UPPER THAMES RIVER
CONSERVATION AUTHORITY

Meeting of the Upper Thames River Conservation Authority Hearing Committee – Agenda
Monday April 20, 2026 1:00pm, 1424 Clarke Rd. London

5. **Application # 195-24**
   Proposed Development upon hazardous lands subject to flooding hazards within a UTRCA Regulated Area located at 5626 Pigram Line, Mount Elgin, Township of South-West Oxford.

Proposed wording for Motion: To sit as a Hearing Committee to consider application #195-24 by **Kevin Conner Paton and their Agent, Paula Lombardi** to consider development within a riverine flood hazard associated with a river or stream valley and within an area regulated by the Upper Thames River Conservation Authority at 5626 Pigram Line, Mount Elgin within the Township of South-West Oxford.

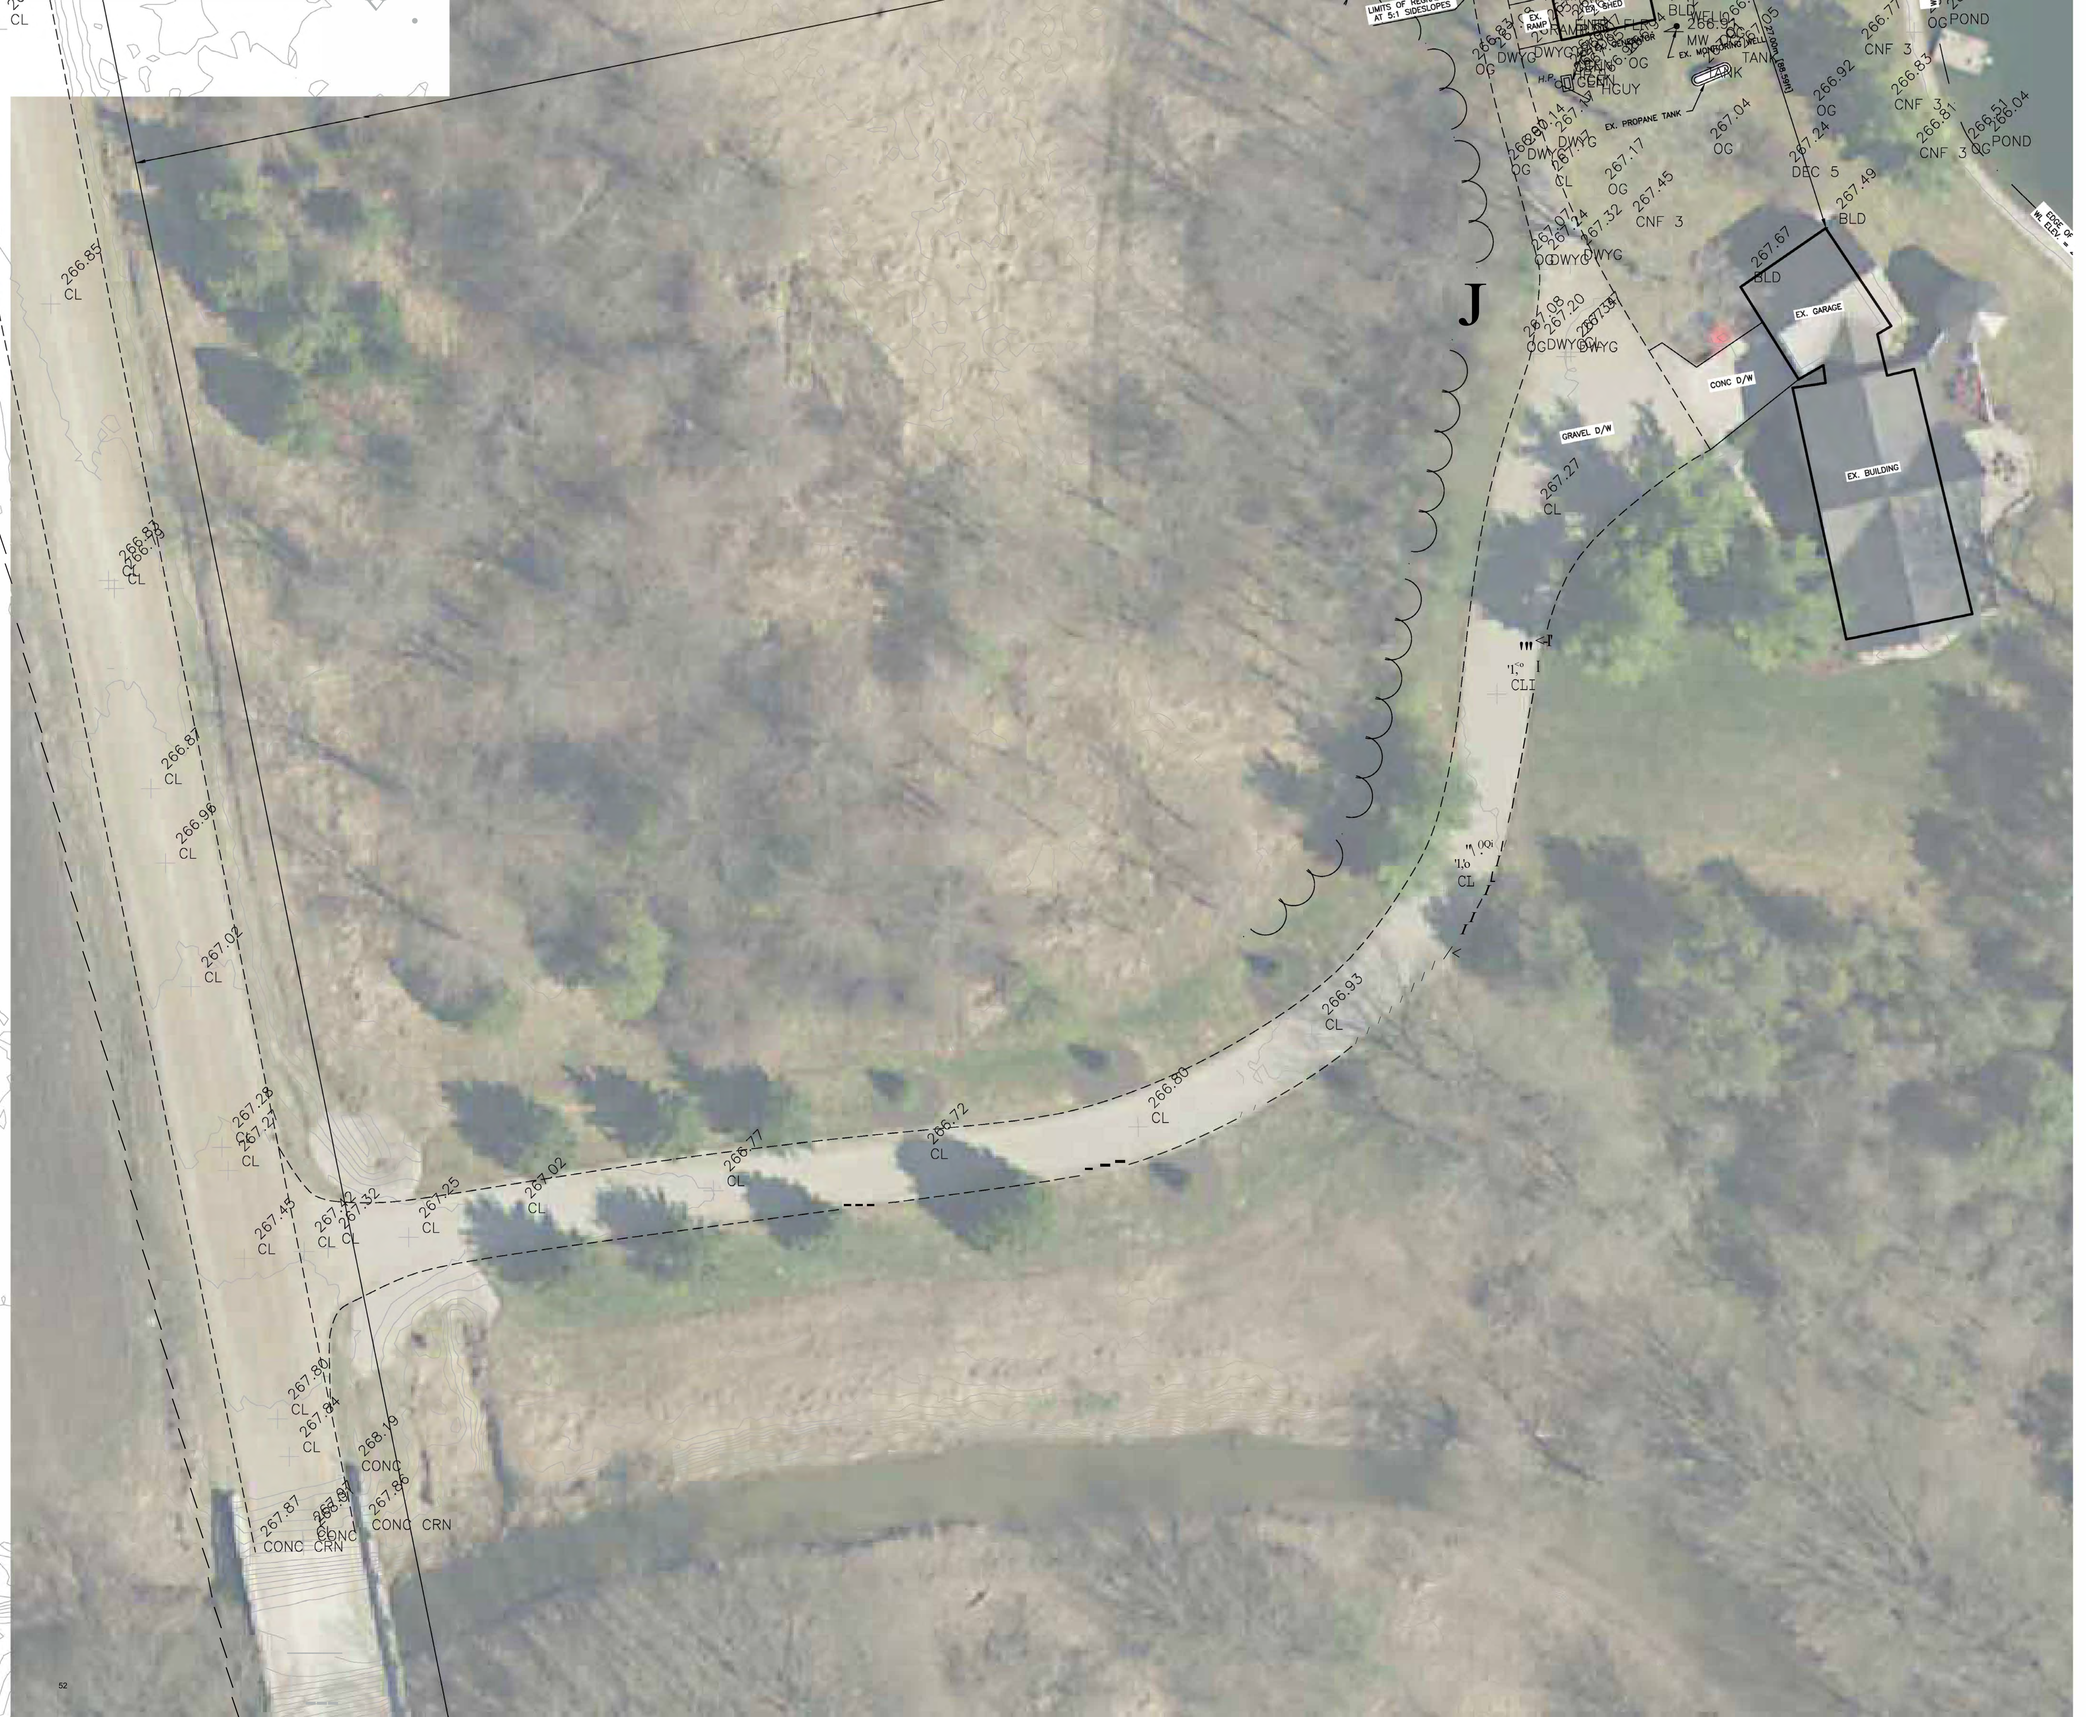
The Grading Plan and Road Centreline surveys submitted in support of the Subject Application confirms that portions of both the existing driveway located upon the Subject Property and the Pigram Line access road to the property are located below elevation 266.9m. These elevations confirm that the flood depths over the access routes to the proposed ARU during a 1:250-year flood event are greater than 0.3m, thereby exceeding the maximum requirements for safe access.

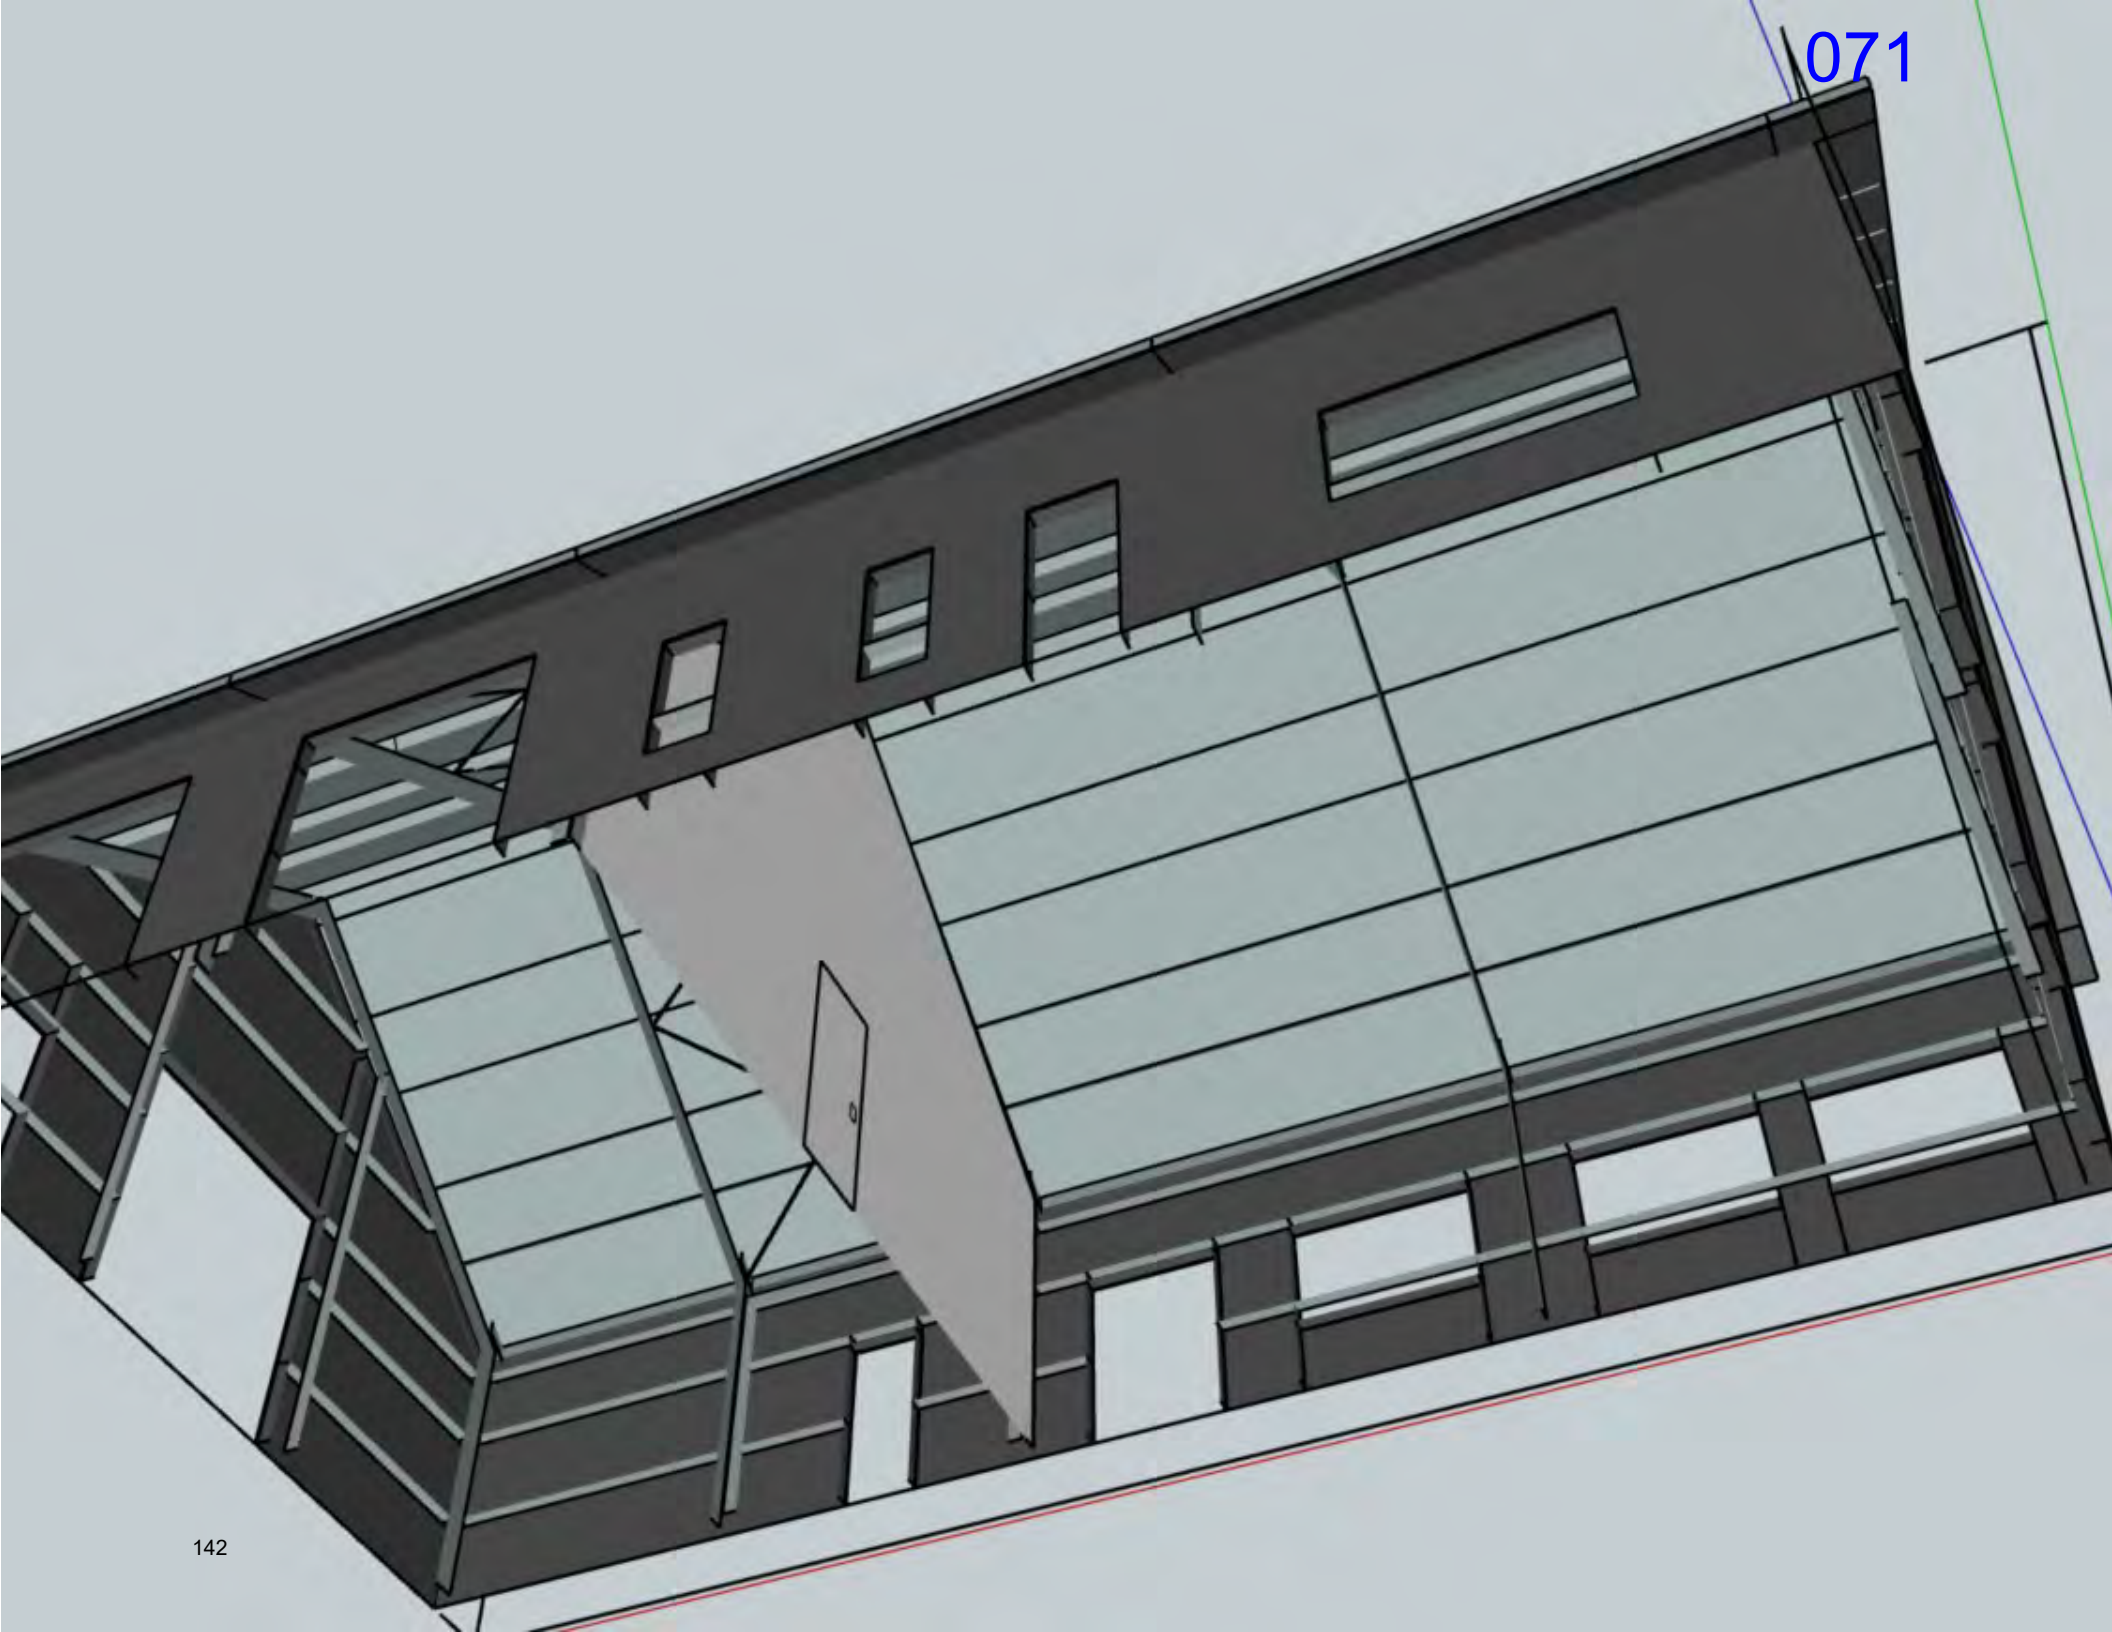
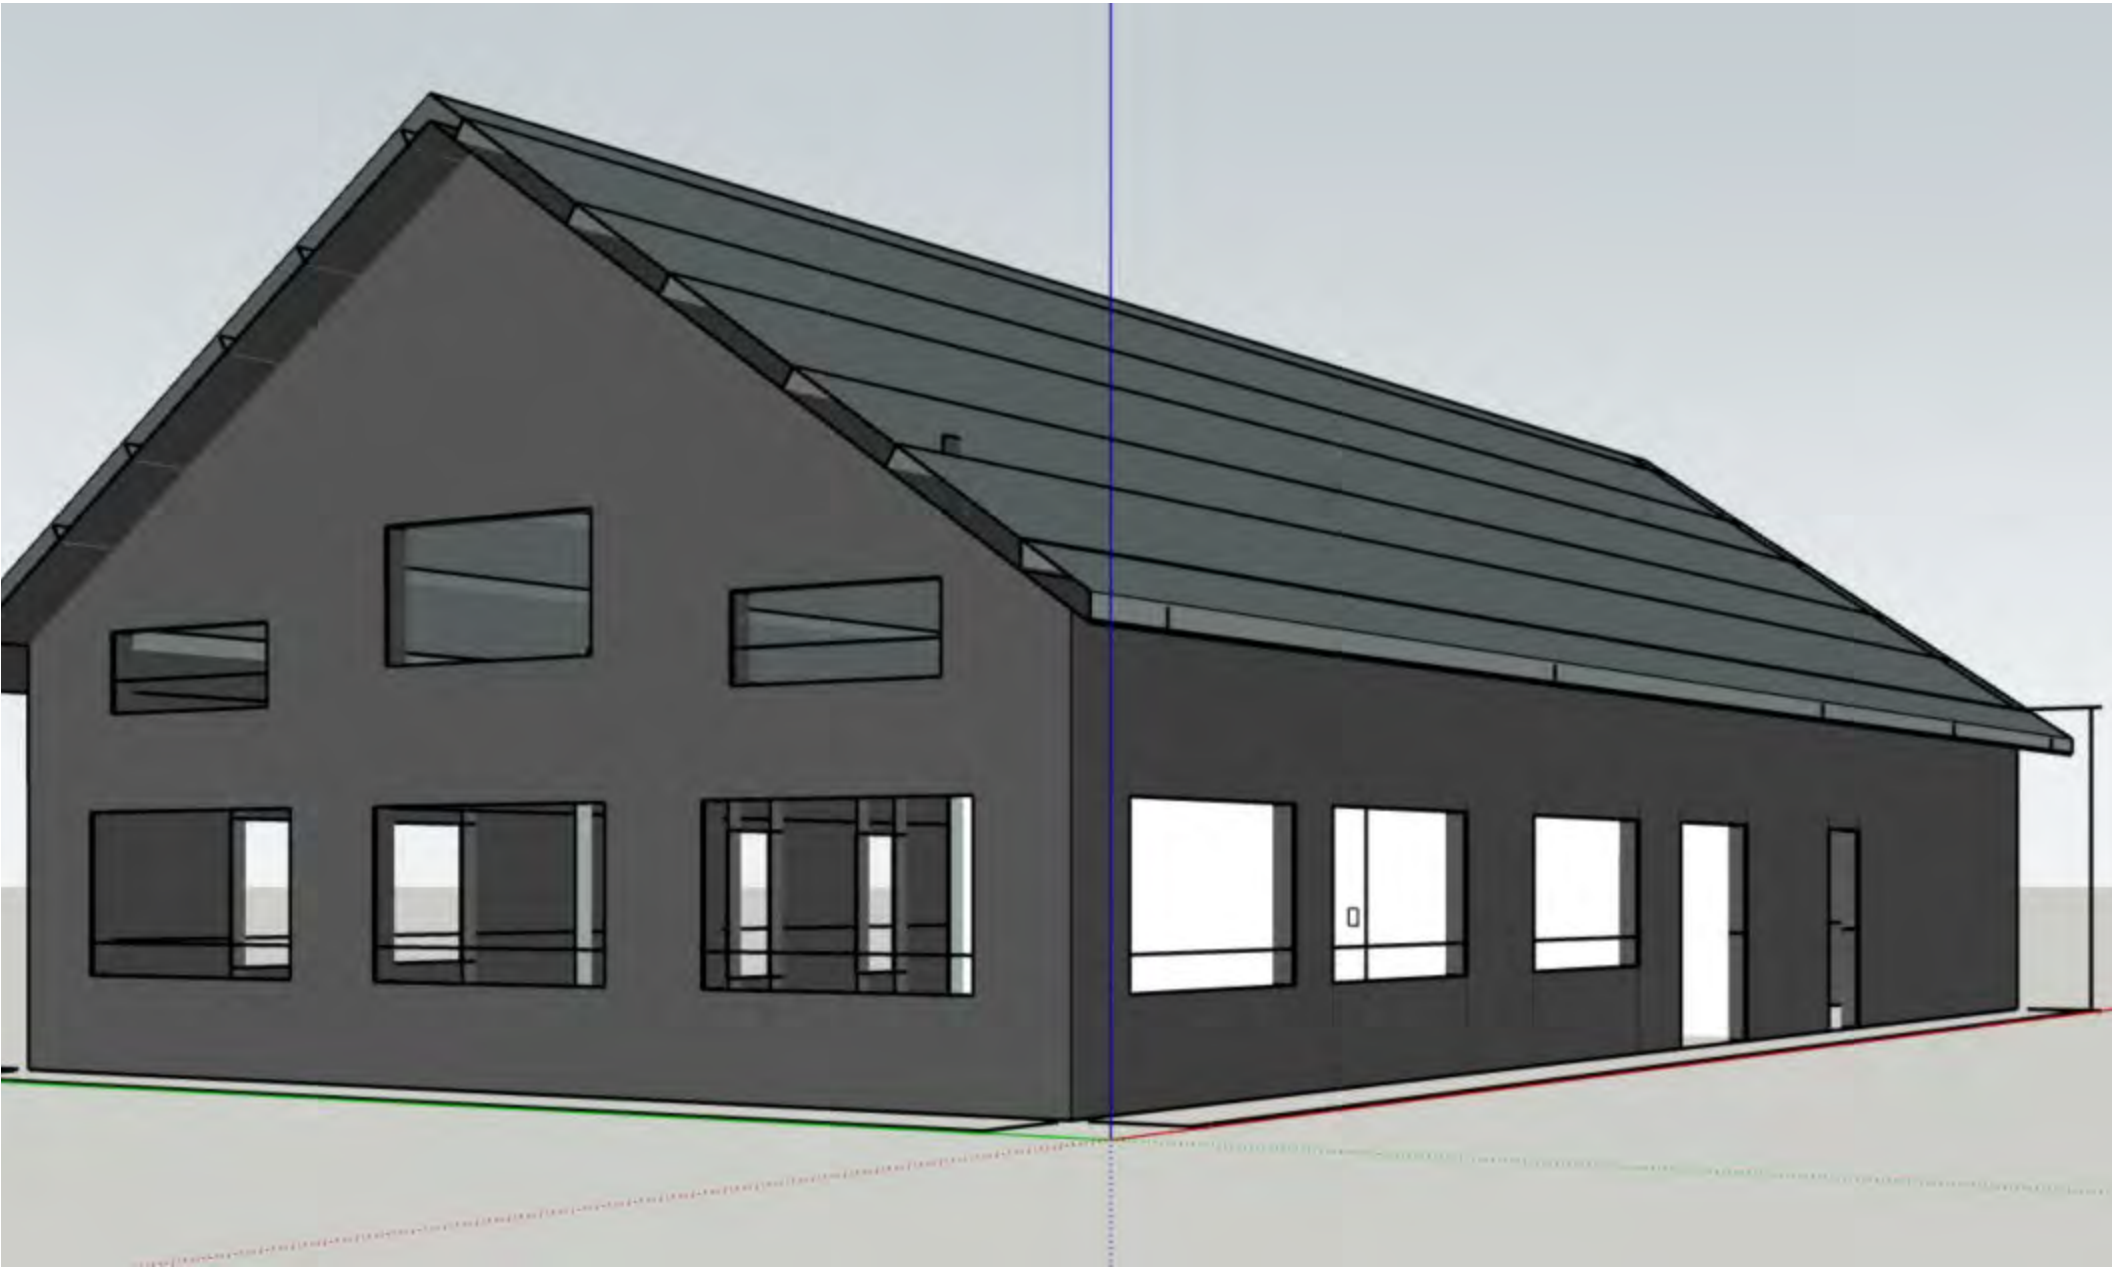
The Upper Thames River Conservation Authority (UTRCA) acknowledges receipt of the Grading Plan for 5626 Pigram Line, Mt. Elgin, prepared by Spriet Associates (Feb 24, 2025) and provided by email on May 15, 2025. It is our understanding that the Grading Plan submission is in response to UTRCA's letter of November 29, 2024, which outlined complete application requirements for the subject matter.

The Grading Plan appears to address some of the information required of UTRCA. However, there are still outstanding requirements and additional comments resulting from our review of the current Grading Plan that are needed prior to the application being considered complete.

However, the Grading Plan does not appear to provide any additional proposed grade elevations or drainage details before and after the development activity. Please provide written confirmation as to whether the proposed project intends to maintain existing grade elevations or whether any additional fill placement or site grading is proposed to accommodate the construction of the new building, including ancillary structures or access standards. Please consider the additional comments within this letter when determining if additional site alterations may be needed.

If additional fill placement or site grading is required beyond the limits of the building envelope, the Grading Plan will need to be updated to show the additional proposed grade elevations and drainage details resulting from fill placement or site grading.

It is our understanding the proposed use of the new building is for an Additional Residential Unit (ARU). Please confirm how the ARU will be serviced for required septic and potable water. Further details regarding the ancillary structures or services location and construction will need to be included on the Grading Plan, if applicable.

We acknowledge that the Grading Plan provides a proposed finished floor elevation. Although that is information required, it does not satisfy the requirement for construction details and drawings, certified by a professional engineer (item #4 of UTRCA letter Nov.29/2024).

Based on available topographic information for lands outside of the area depicted on the Grading Plan, it does not appear that even safe access is available to the subject property. Portions of the existing driveway and Pigram Line roadway appears to be inundated by flood depths greater than 0.3m during a regulatory storm event based on the 267.2m elevation.

1. Revised Grading Plan to address the comments of this letter, if applicable;
2. Construction details and drawings for all new buildings or structures which must include proposed flood-proofing standards to the level of the regulatory flood standard (267.5m) as certified by a professional engineer; and
3. Confirmation of how safe access standards are being addressed. This could be accomplished by providing additional grade elevations for existing and proposed grades along the entire length of the driveway access and the entrance at Pigram Rd.
